Memorandum

Subject: Work session report for the July 31, 2008 meeting on the Plano Road Subdivision proposal, CAR07-00042/DA, CUP07-00084, CFH07-00022 and SUB07-00065

Plano Road Subdivision Proposal Work Session Topics

Exhibit 4 - Plano Road Proposal - Building Envelope Placement Within Buildable Area

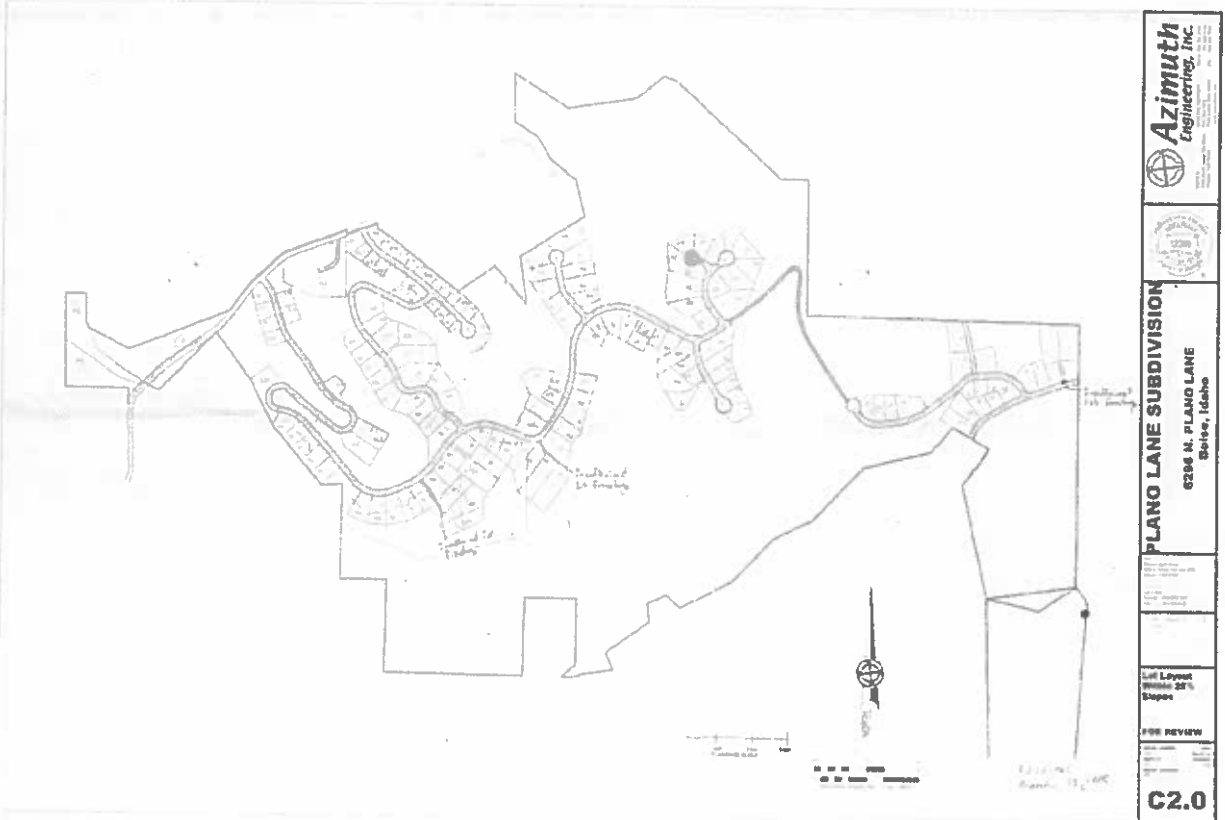
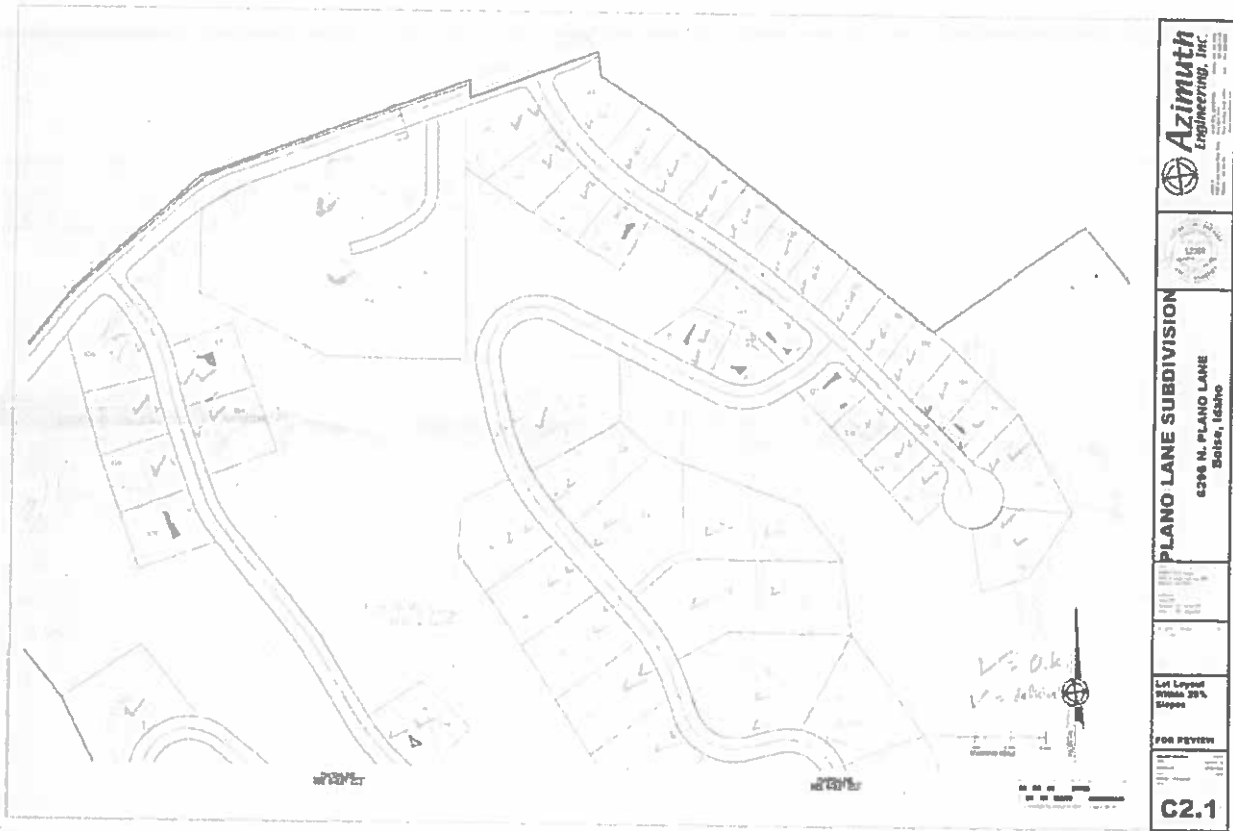
14. Examine the issue of buildable vs. non-buildable areas of the proposed site; are they truly buildable. If not, then they should be removed from the calculation. I had asked the applicant about the sandpit and why the development wasn't being placed there on ground that had already been disturbed. His response was that it wasn't really constructible, that the amount of fill that you would have to put in there to be able to engineer it to support housing, that he was much more comfortable placing the housing on ground that has been there for hundreds of years rather than new ground that would be filled and constructible.

Buildable is defined below as it pertains to the development pockets, where some areas of non-buildable land are allowed to accommodate the site design. The attached table and detailed maps, Exhibit 4, Plano Road Proposal - Building Envelope Placement Within Buildable Area, also examines each proposed lot to determine if they comply with the standards.

~~Response-14:~~ The Applicants' civil engineer confirmed after the July 14 hearing that the sand pit and other areas having a slope of 25% or less located on the property are "buildable." The Applicants apologize for any confusion caused by the erroneous response to the contrary given at the hearing. However, because no density bonus is actually being utilized by the Applicants, the question of whether the sand pit and other areas are buildable is largely irrelevant to the pending development proposal.
